Purple Line on Wayne Avenue: Questions from the Community

Joint meeting of the Park Hills Civic Association & Seven Oaks Evanswood Citizens' Association
May 22, 2017 – Silver Spring Civic Center

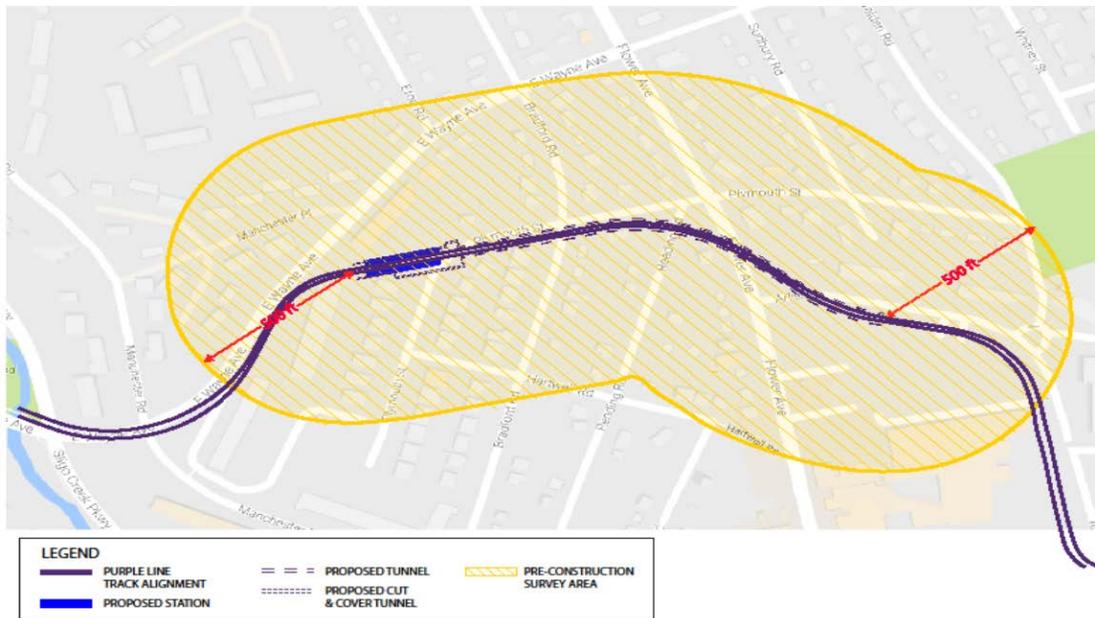
Q10: What is the range of impact (range of feet in diameter) for residents near the blasting site at Manchester Road?

Blasting will only occur where needed in the tunnel during day-time hours of 7 a.m. to 7 p.m. Blasting will occur up to two times a day (lasting only seconds). No blasting will occur on weekends. The impact to residents should be minimal and PLTP anticipates no damage. Extensive monitoring will be put in place prior to any blasting occurring. PLTP has established a 500-foot diameter to perform preconstruction inspections around the tunnel area where blasting will occur prior to any start of construction. See drawing below.
